UNITED STATES
NUCLEAR REGULATORY COMMISSION
WASHINGTON, D. C. 20555

H. B. ROBINSON STEAM ELECTRIC PLANT, UNIT NO. 2

AMENDMENT TO FACILITY OPERATING LICENSE

Amendment No. 70
License No. DPR-23

Fig. 6.2-1

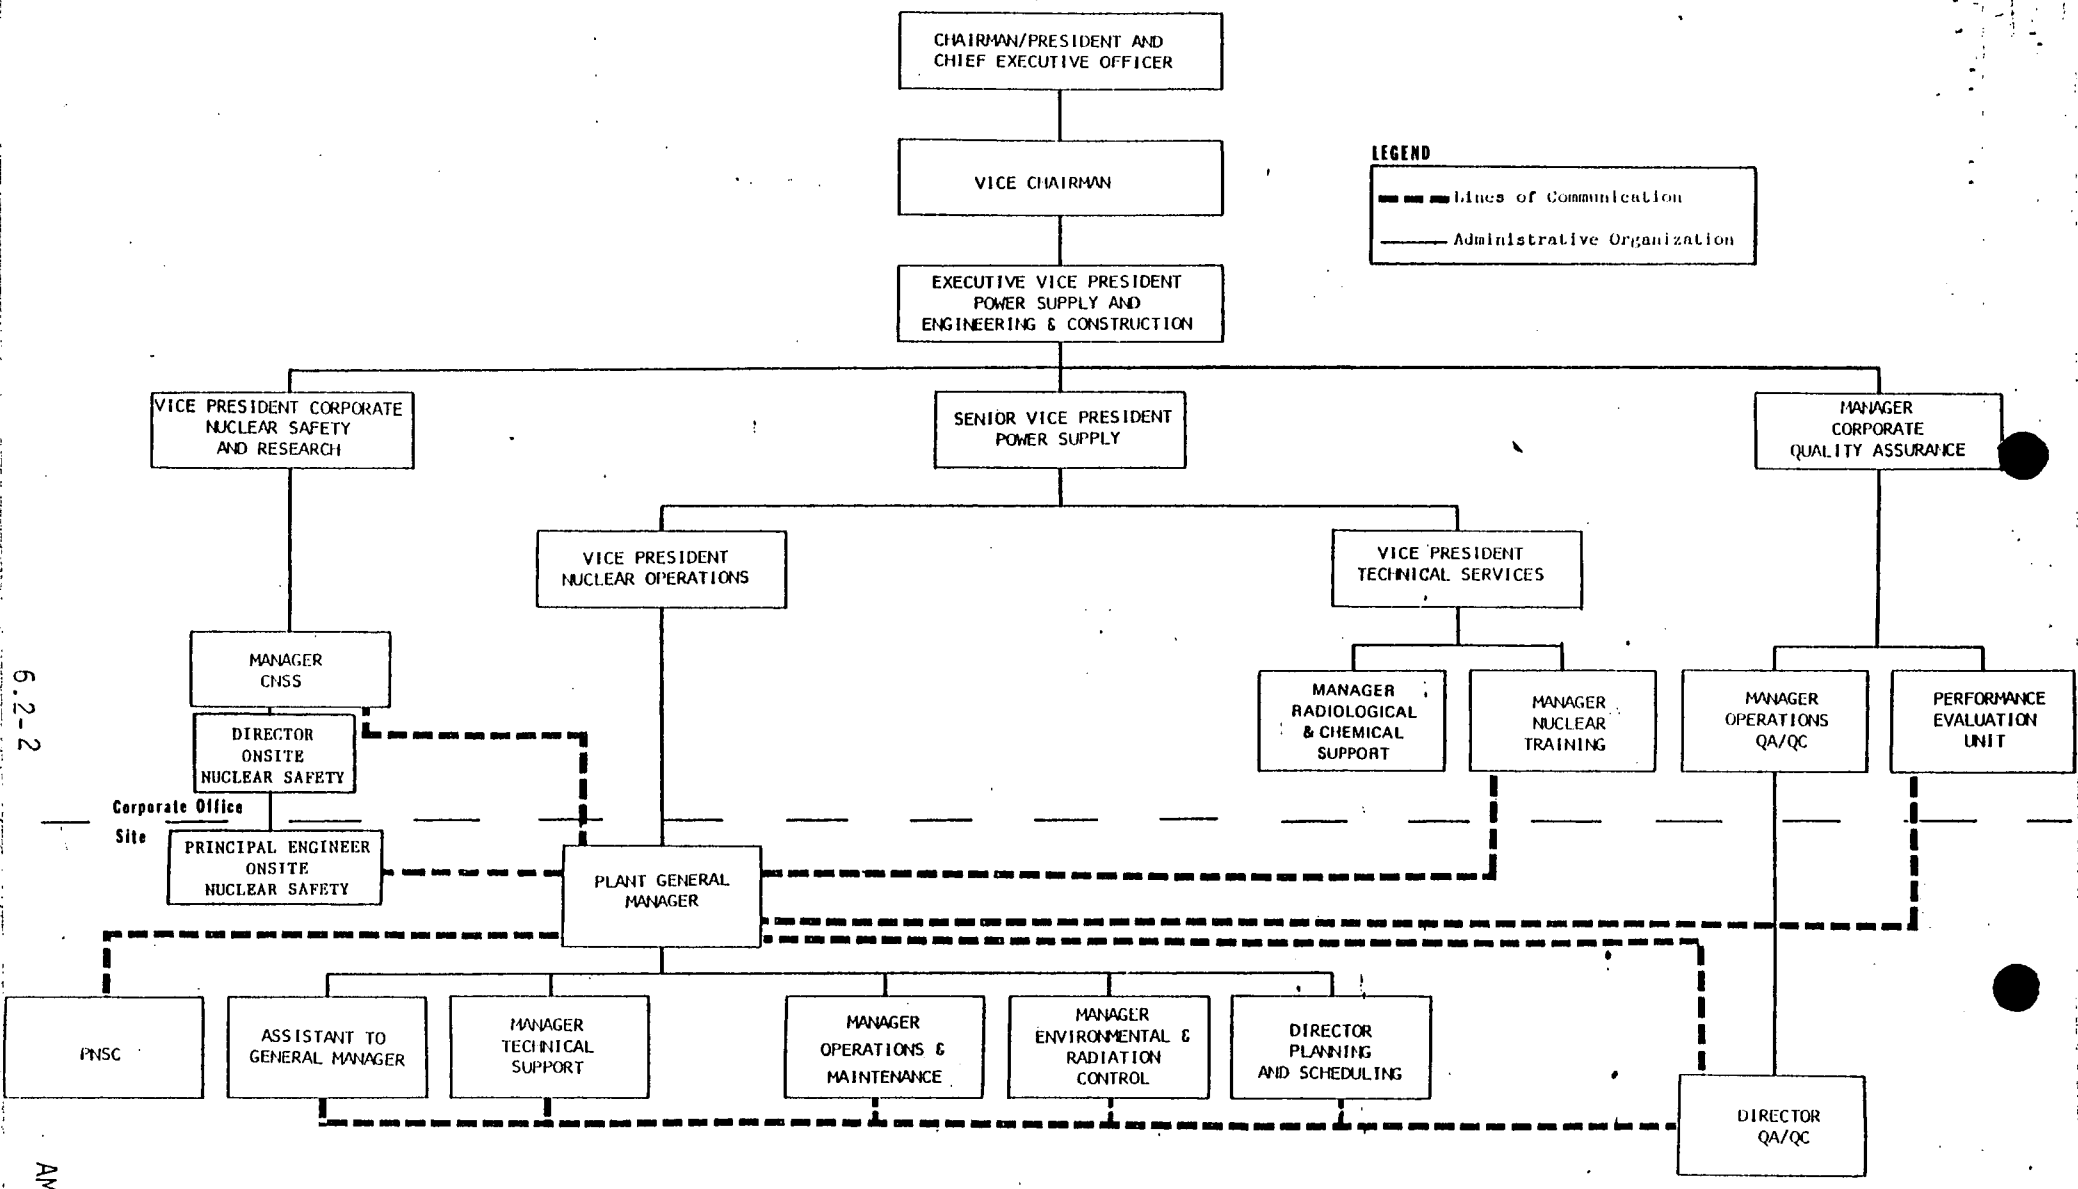
6.2.1 The offsite organization for facility management and technical support shall be as shown on Figure 6.2-1.

Fig. 6.2-2

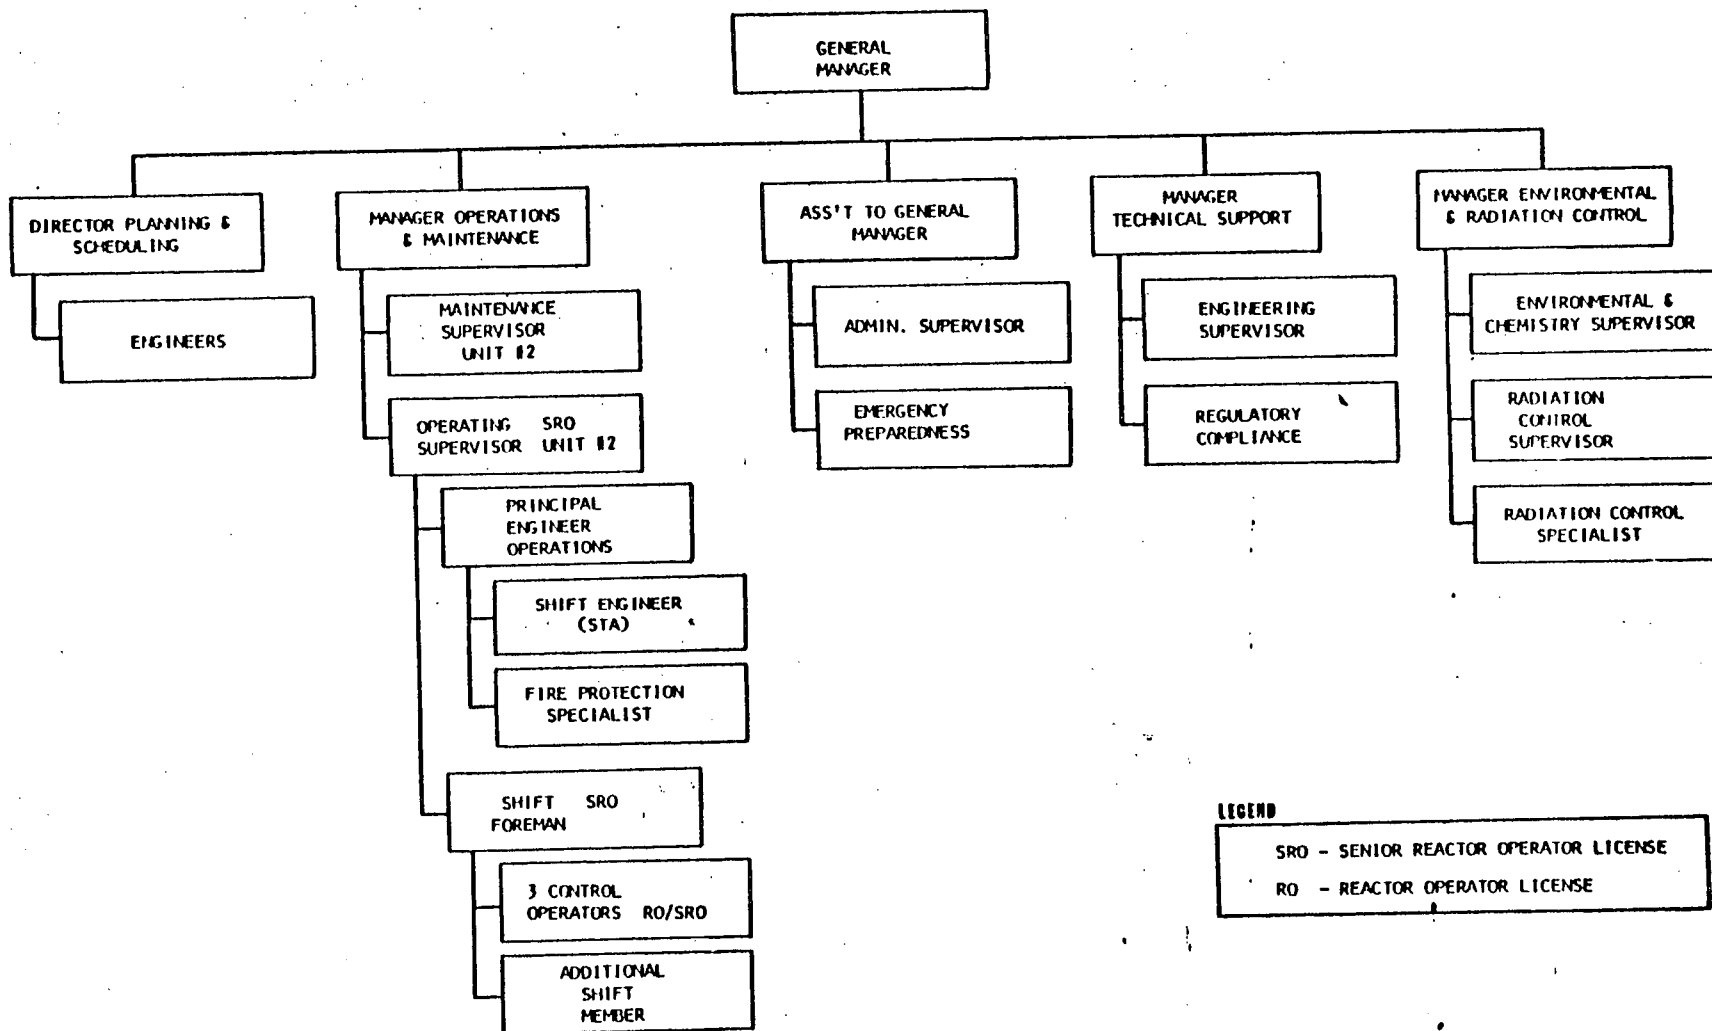
6.2.2 The facility organization shall be as shown on Figure 6.2-2 and:

- a. The shift complement shall consist of at least one Shift Foreman holding a Senior Reactor Operator's License, three control operators each holding at least a Reactor Operator's license, one additional shift member, and one Shift Engineer (shift technical advisor).
